CONSUMERS POWER COMPANY  
DOCKET NO. 50-155  
BIG ROCK POINT NUCLEAR PLANT  
AMENDMENT TO FACILITY OPERATING LICENSE

18  
 Amendment No. 20  
 License No. DPR-6

ATTACHMENT TO LICENSE AMENDMENT NO. 40

Figure 6.2-2

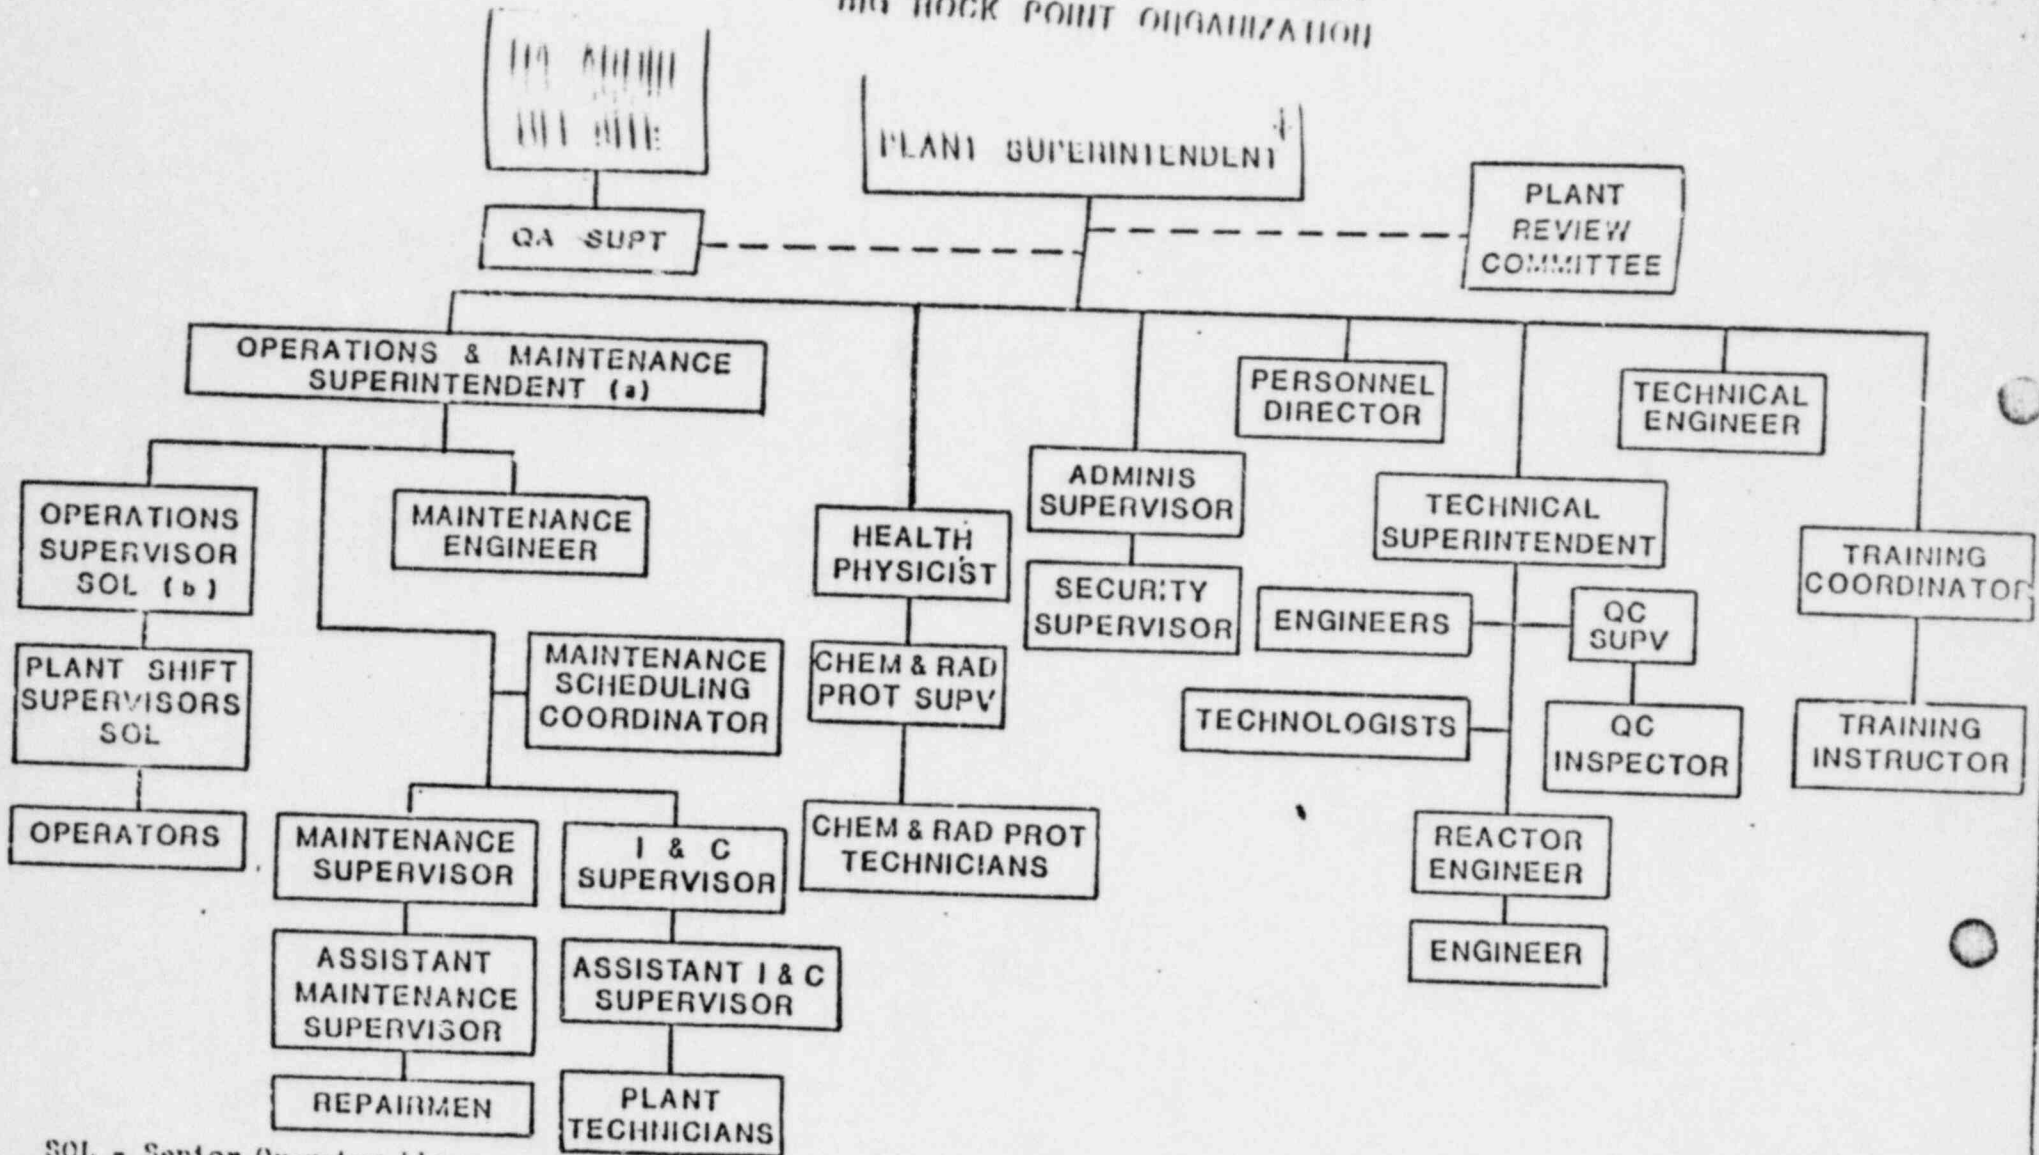
- (a) The Operations & Maintenance Superintendent need not hold an SOL provided he meets the other requirements of 6.3.1 of these specifications and the position of "Operations Supervisor" is filled. Under these conditions, the Operations Supervisor shall be responsible for directing the activities of licensed operators.
- (b) This position need not be filled if the Operations & Maintenance Superintendent holds an SOL.

\*Responsible for overall implementation of the plant Fire Protection Program.
